Objection - Planning Application RU.22/0454 Land to the east of Brox Road, Ottershaw KT16 0LQ

Brox Road Action Group (BRAG)

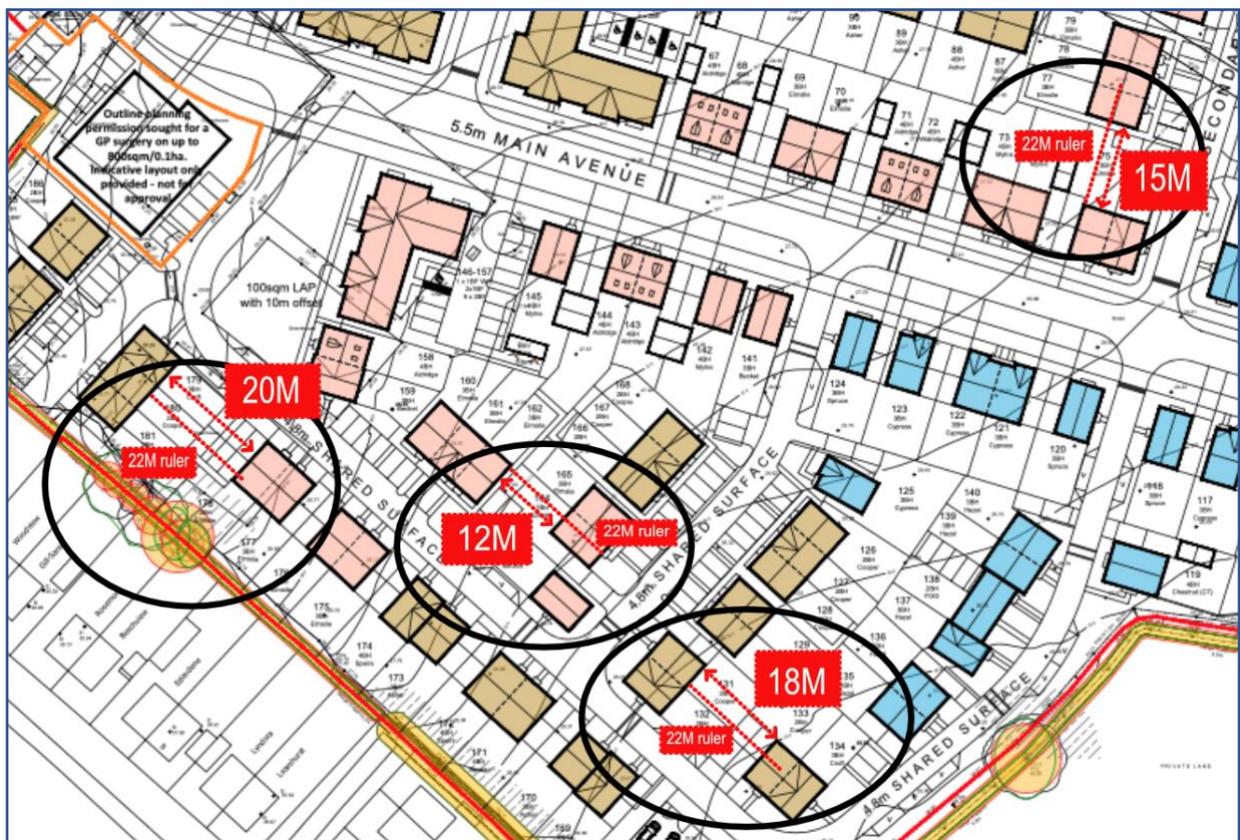
The diagram below shows minimum distances between those dwellings *within* the development that are offset side to back arrangements. The distances range between 12 – 20M. They are carefully orientated so that rear gardens obtain the maximum amount of daylight.

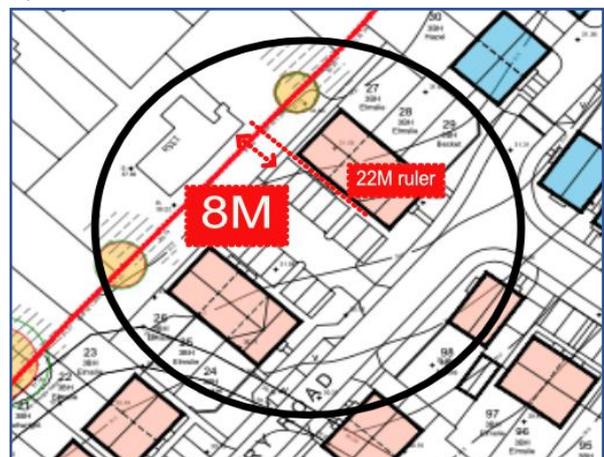
Compare this to the layout behind 135A Brox Road, where the distance is a mere 8M. The 2 terraced blocks are placed to cause overshadowing of this property as it derives its daylight from a southeast direction. Overlooking occurs from close angular distances, and proximity causes loss of outlook. The large size of these housing blocks causes intrusion and visual dominance at very short distance. This arrangement is not evident for the commercially valuable new dwellings.

Replacing the 2 terraced blocks with 2 sets of semi-detached houses reduces the overshadowing, dominance, and overbearing nature of the structures so close to the existing dwelling. The relationship and response to context are improved. The parking court is reduced from 12 to 8 spaces and moved further back in mitigation for departing from a back-to-back arrangement. The break between the existing and new dwellings helps to relieve the built form and allow for natural landscaping adding valuable green space.
